PLAN COMMISSION / ZONING BOARD OF APPEALS AGENDA

Future Public Hearing Request: Special Use Permit for a self-service storage facility in the I-2 General Industrial District, Special Use Permit for extended hours of operation, Zoning Variations pursuant to parking and loading requirements (Article 7 Section B), Preliminary and Final Plat of Resubdivision (to consolidate lots and tax parcels), and approval of a retaining wall's height and length (PINs: 19-09-34-103-008-0000, 19-09-34-100-065-0000, and 19-09-34-100-064-0000).

E FACILITY PLAN INDUSTRY AVENUE STORAGE
PRELIMINARY ENGINEERING
FRANKFORT, IL

SHEET NUMBER L1.0

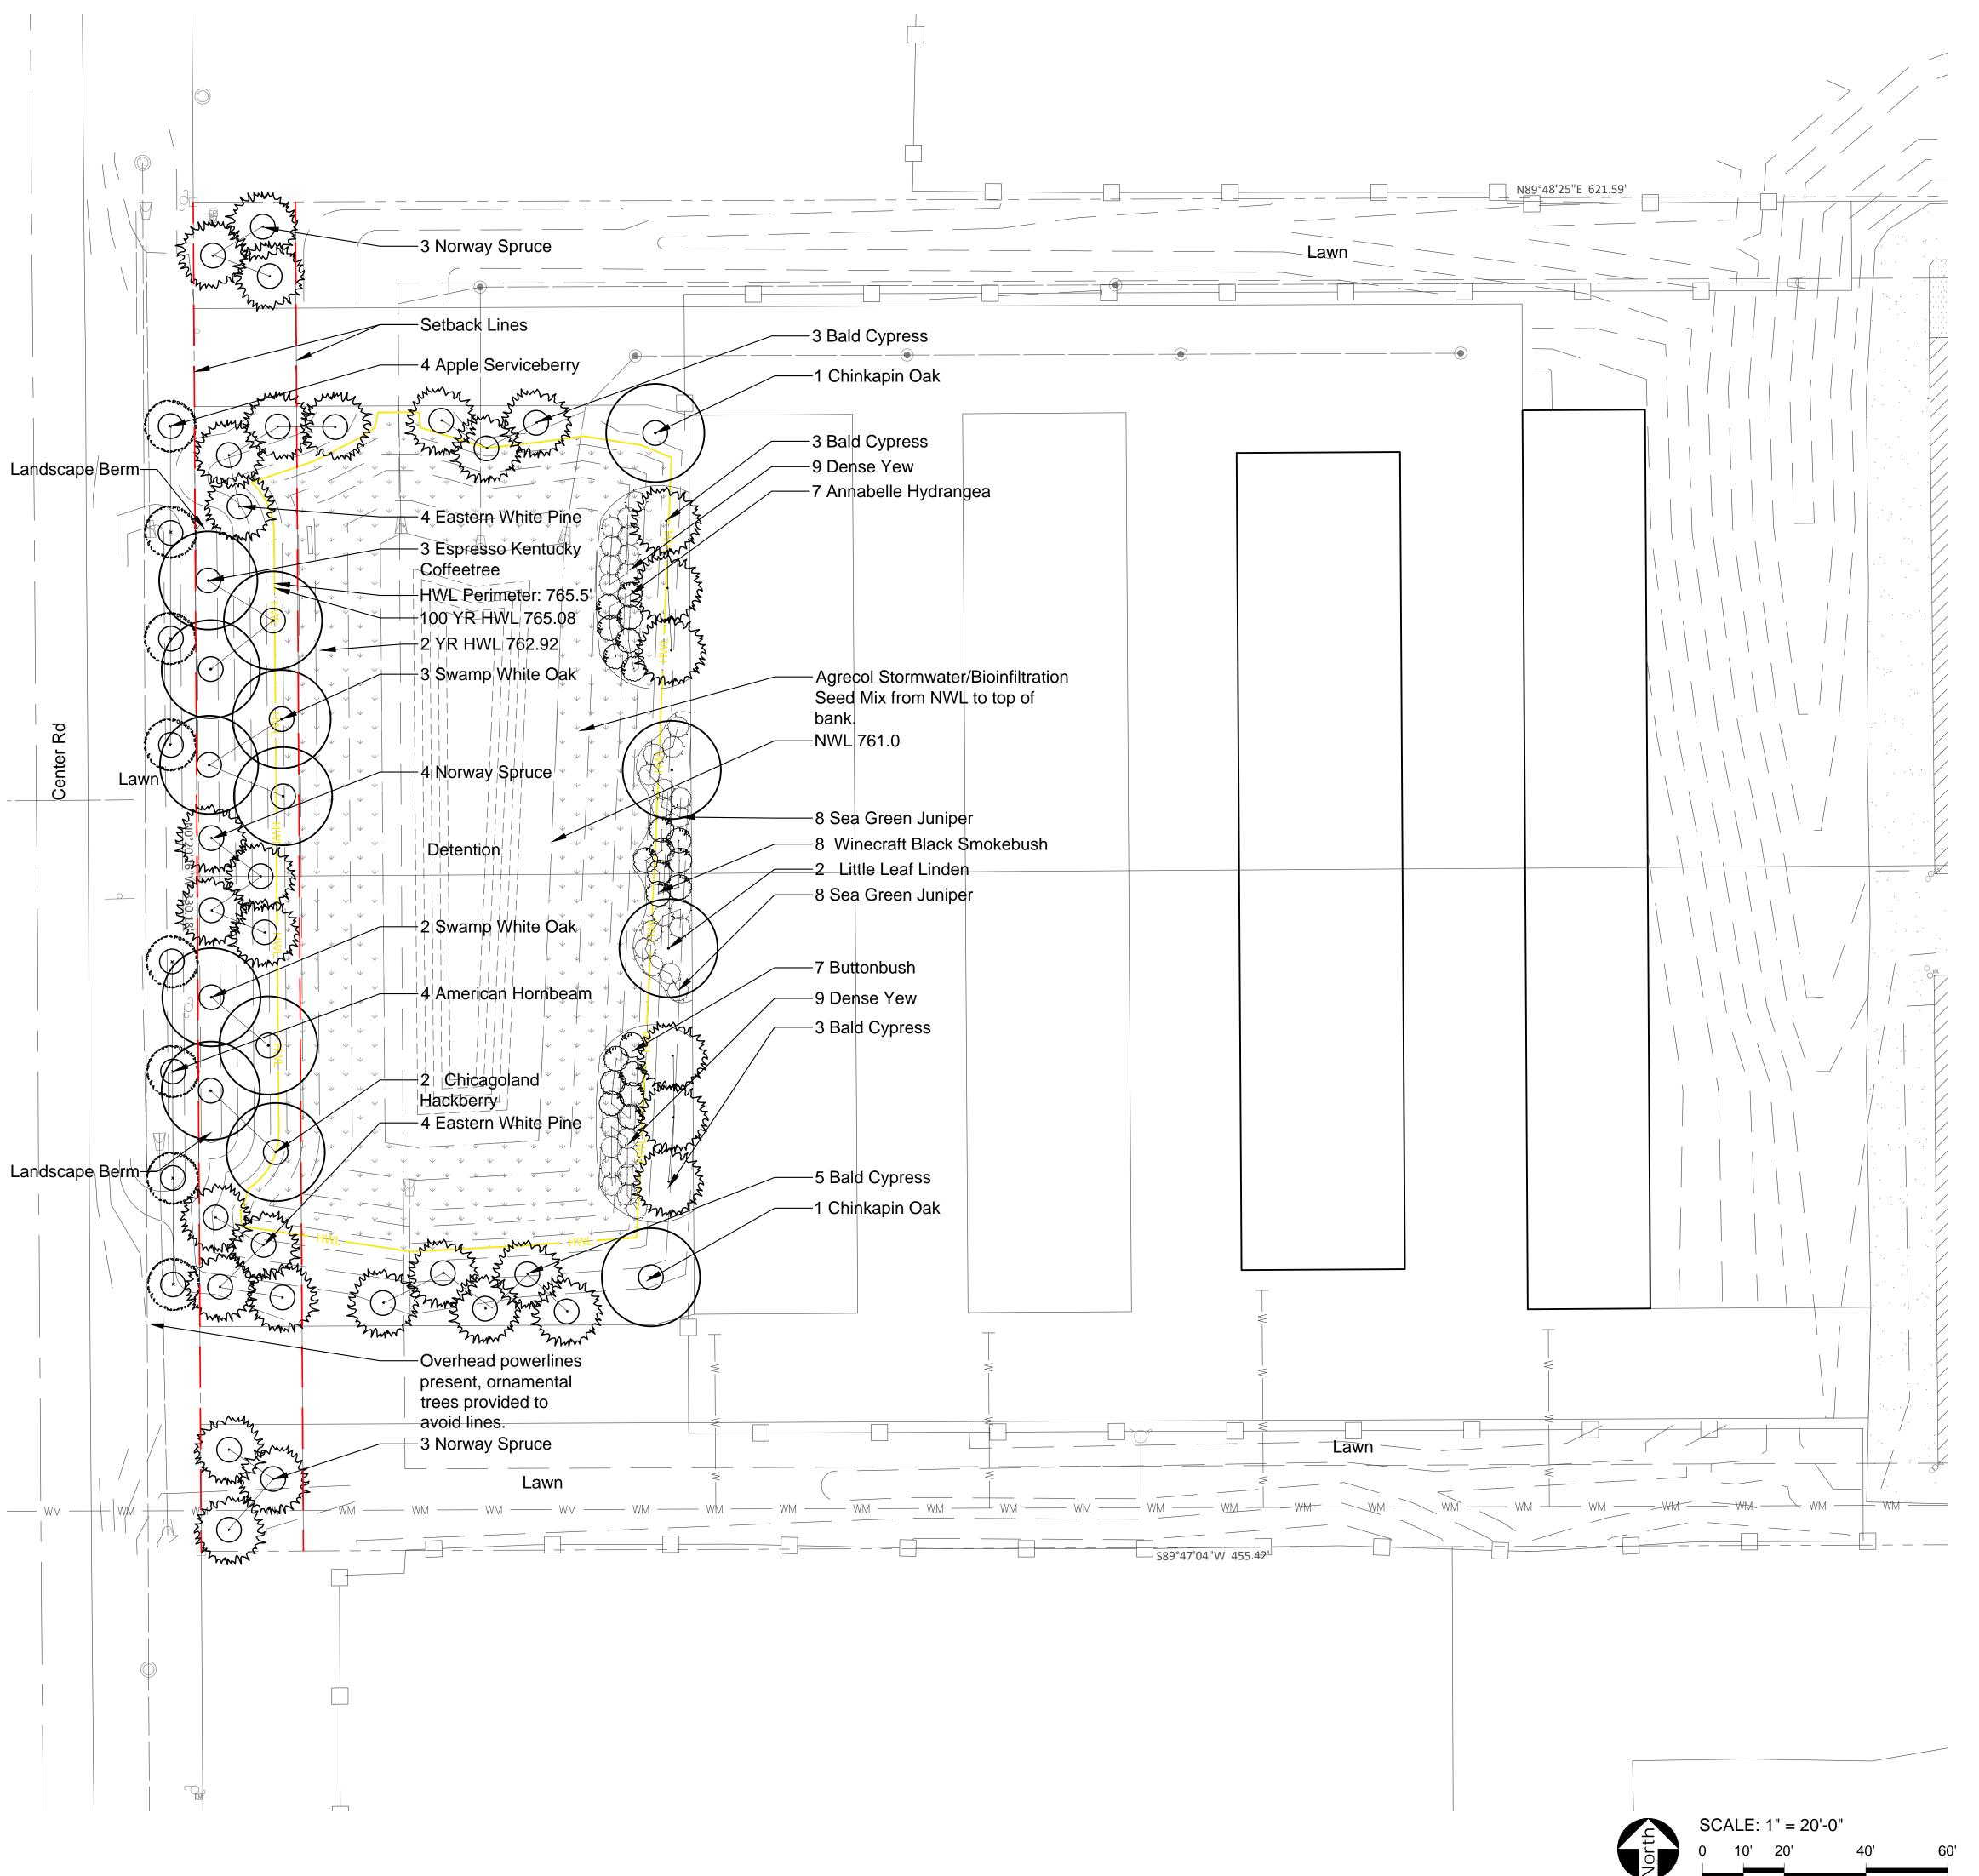
- 1. The applicant has submitted a Landscape Plan. Staff provided the applicant with the below recommendations/request for revisions:
 - a. 13 parkway trees are required (the requirement is 1 per 25' and there is 330' of frontage per the submitted plans). 8 parkway trees are currently provided.

- b. In the landscape setback, 413 plant units are required. The current Plan depicts 356 plant units.
 - c. Additional plantings are needed to meet the screening requirement (self-service storage use regulations mentioned in the Zoning Ordinance). Staff notes that it may be hard to squeeze all landscaping that is needed in just one area, I recommend providing the landscaping on the north and south property lines shown on the landscape plan.

SHEET NUMBER L1.1

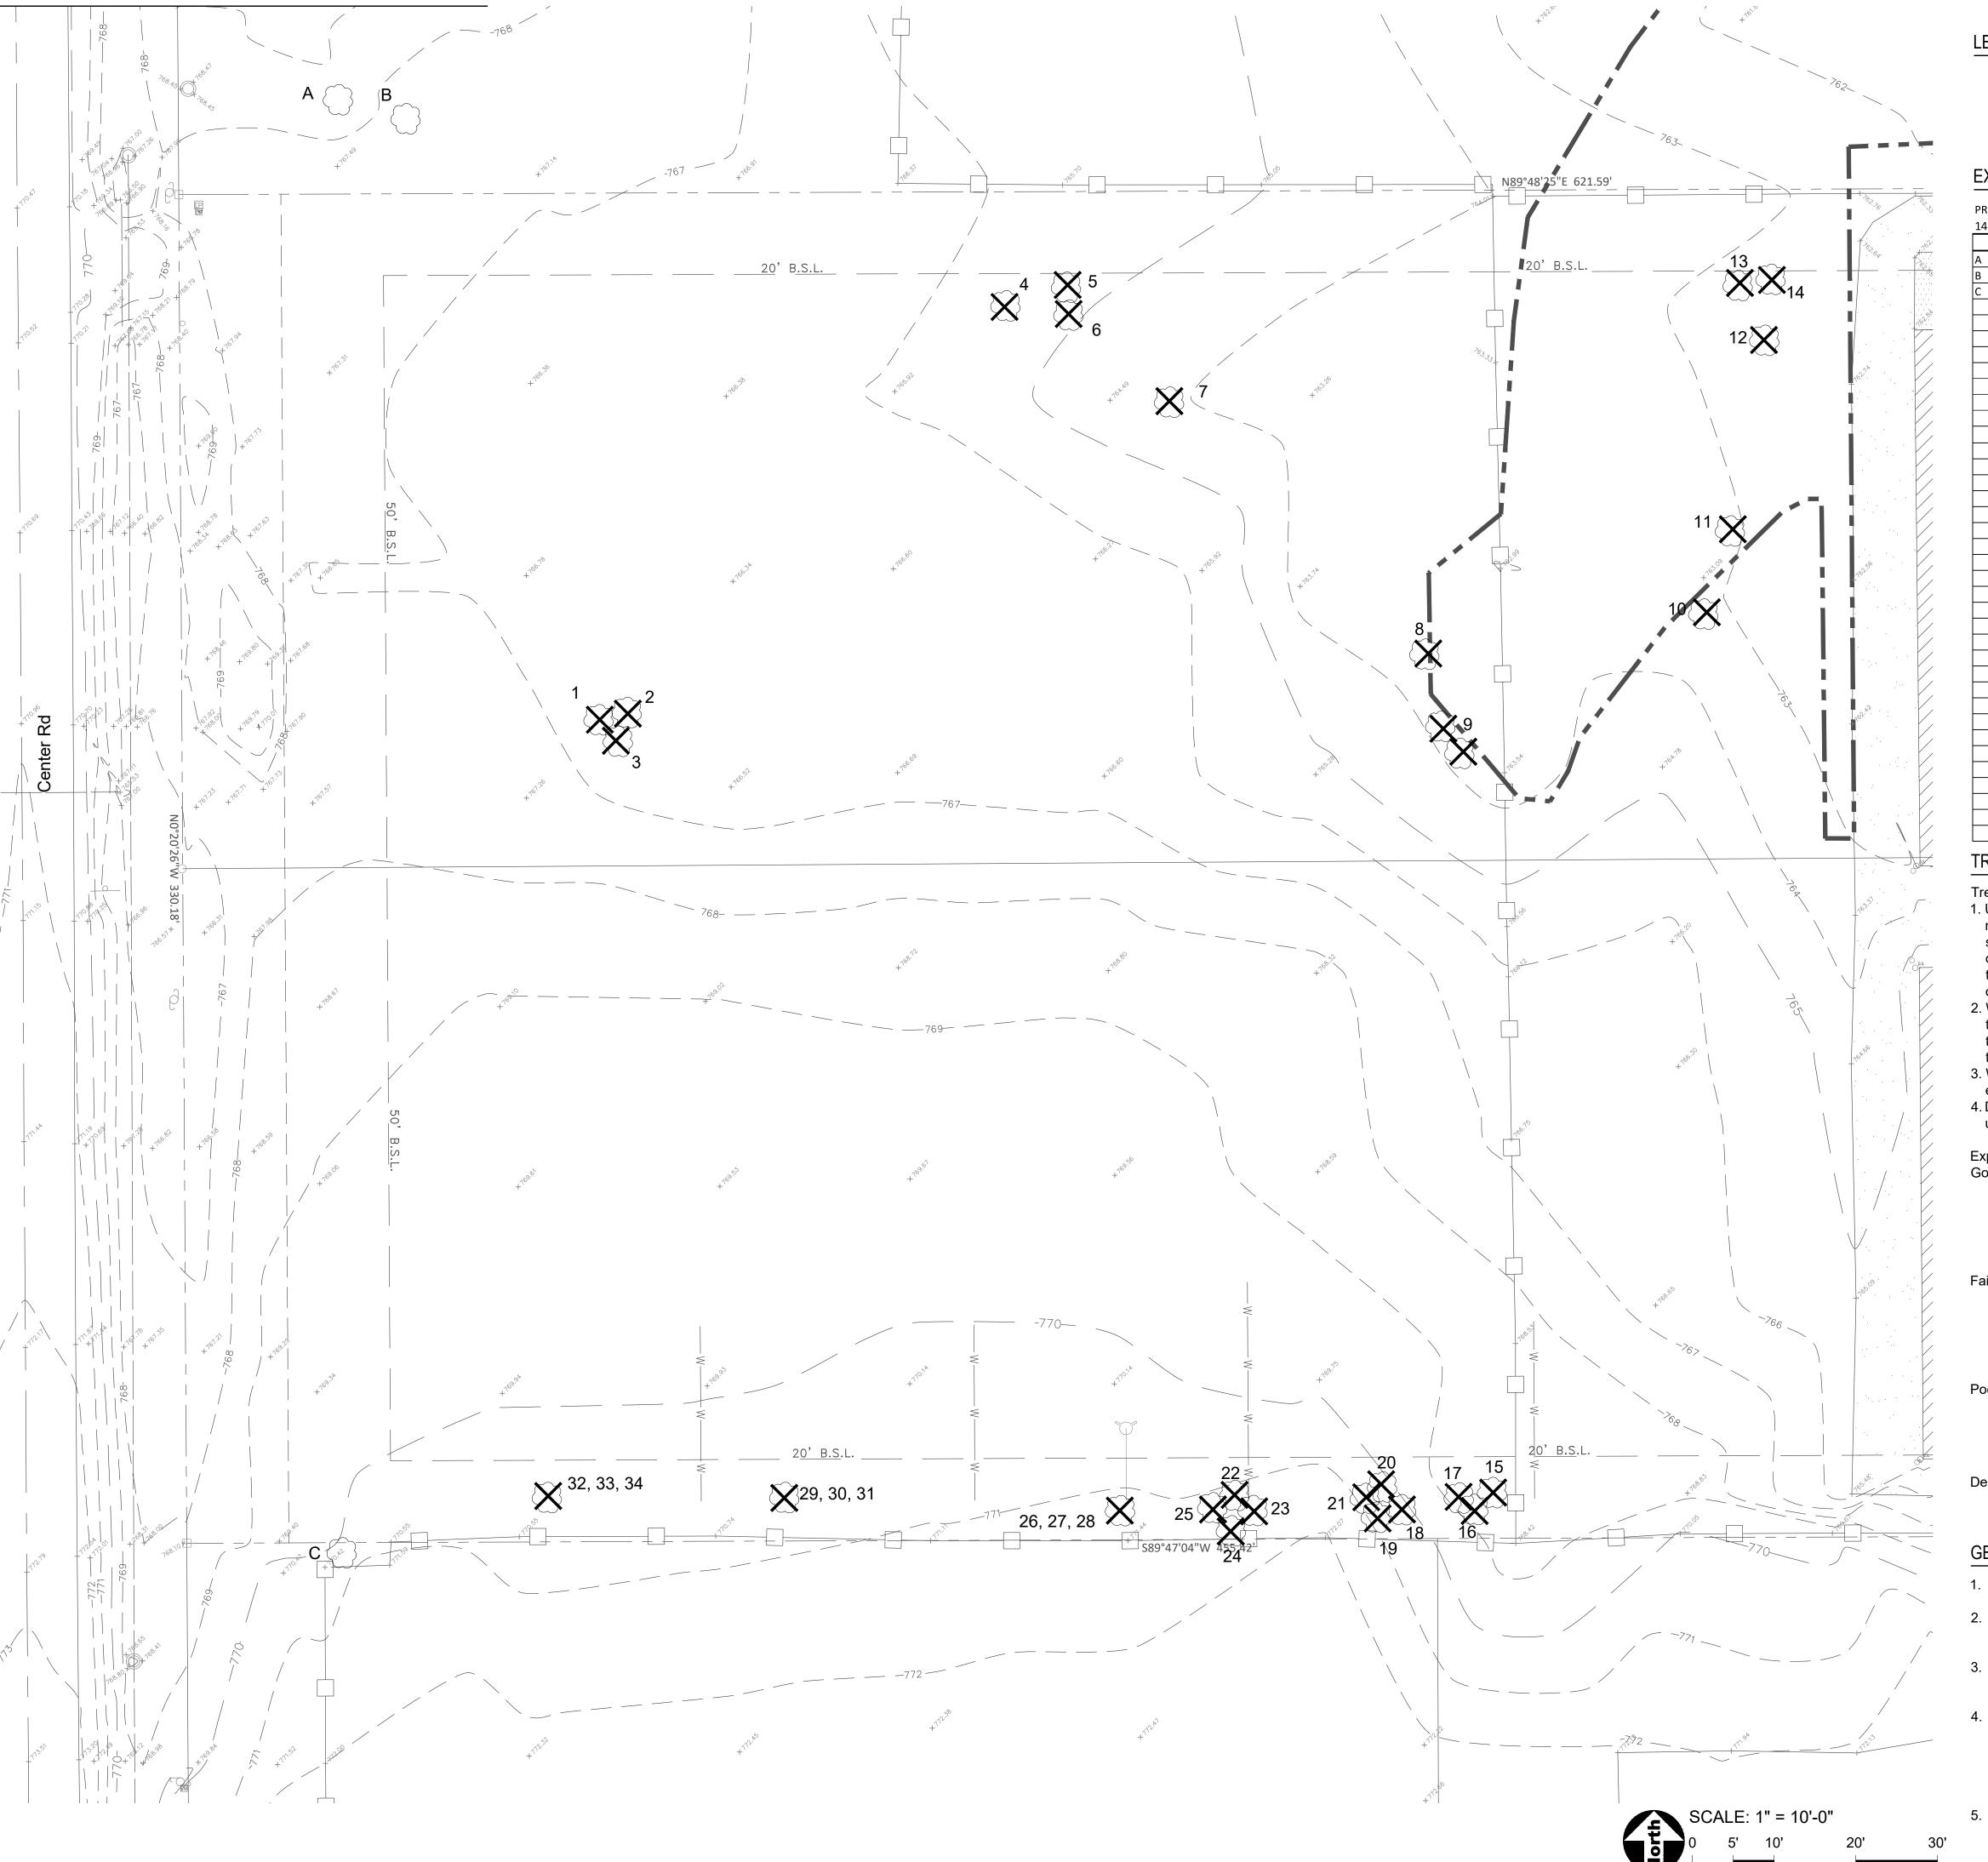
- 2. The applicant has also submitted a Tree Preservation Plan which includes a survey of the existing trees on the site (some trees shown are on adjacent north and south properties).

- 3. The Tree Preservation Plan depicts the removal of 34 existing trees on the subject site. Per the tree survey on the Plan, 17 of the 34 trees depicted for removal are noted as being in poor condition. Staff finds that none of the trees planned to be removed are classified as Preservation Trees per Appendix E of the Landscape Ordinance. The 3 trees planned to be preserved on the Plan are located on the adjacent north and south properties.

NORTH ELEVATION
4 A2	scale: 3/16"=1'-0"

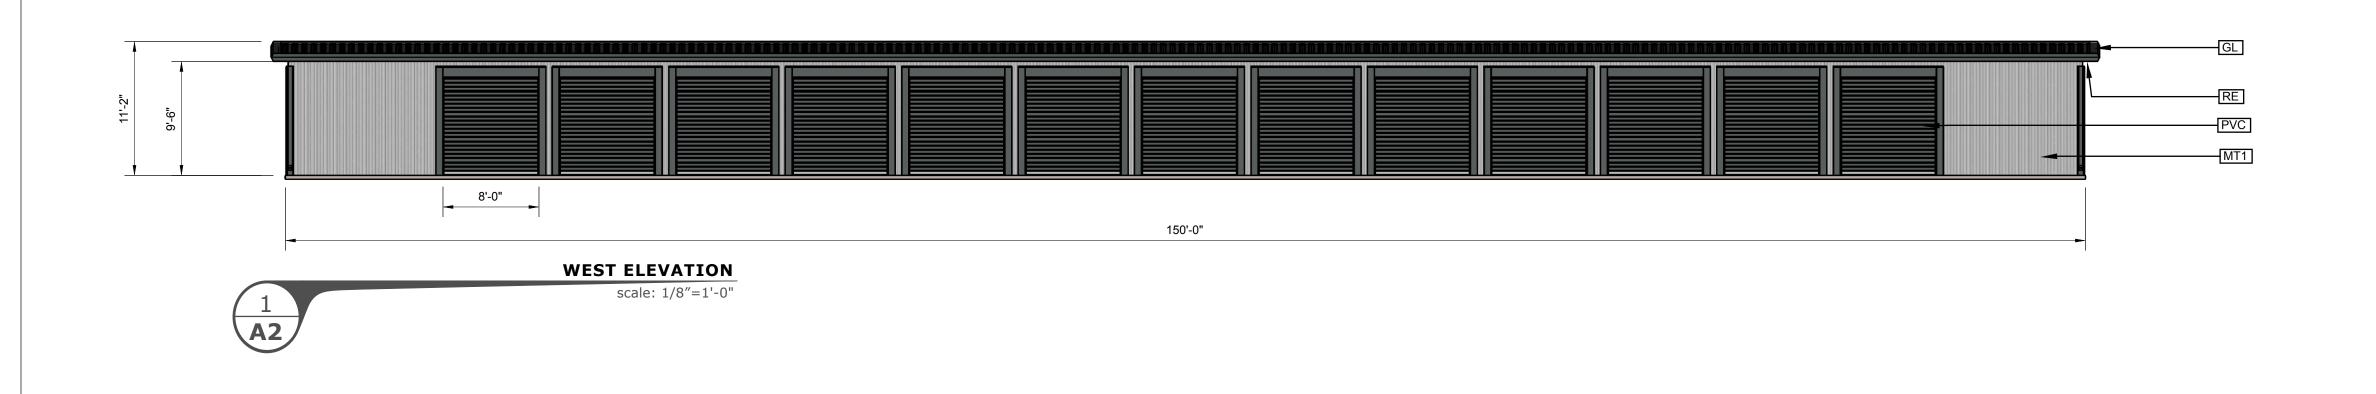
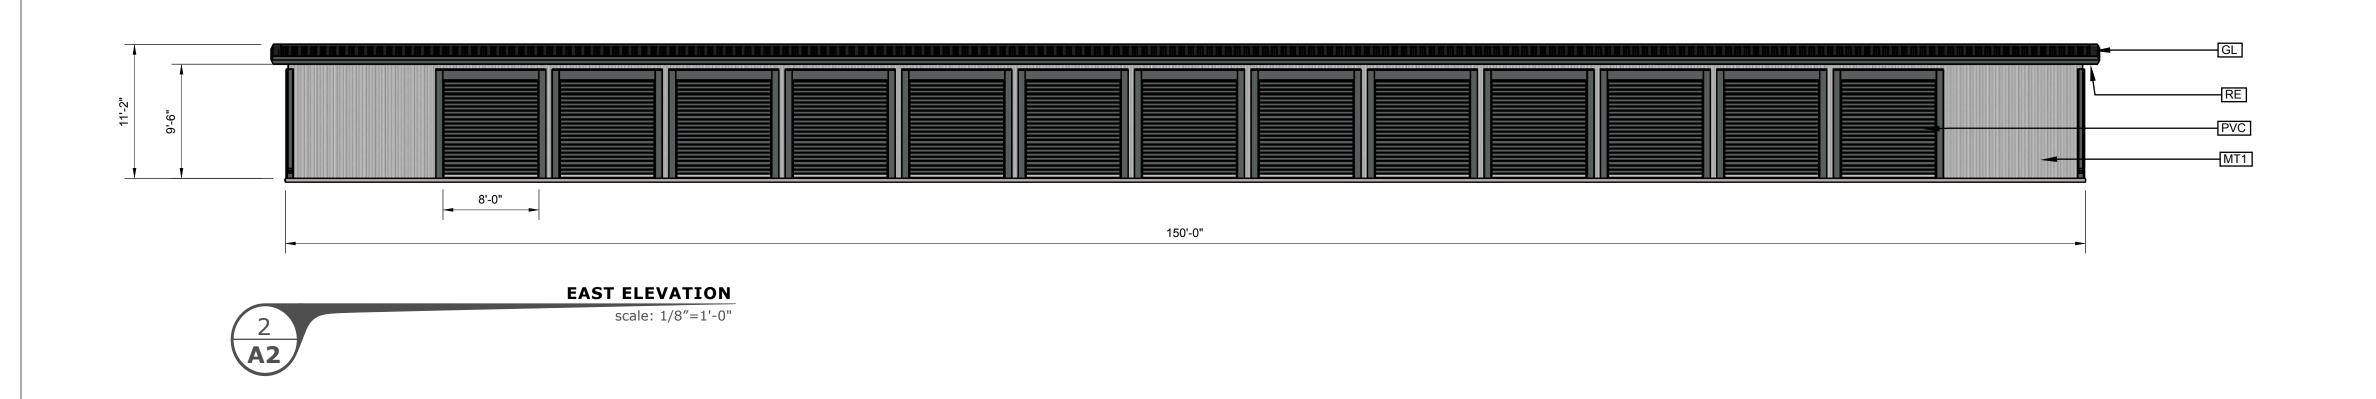
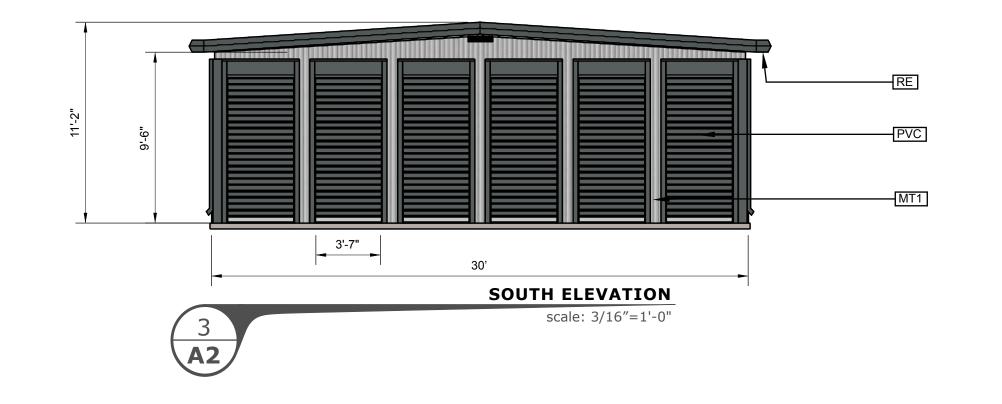
- 6. The applicant provided an additional typical elevation sheet for the other proposed buildings (sheet A2 of the submitted elevations). Below is a breakdown of the building materials and architectural features to expect on the proposed buildings east of the "Building 1":

- a. Clarification that the submitted elevations depict all proposed buildings. Staff recommends that an elevation sheet for each building be provided and labelled "Building 1, 2, 3, and 4".
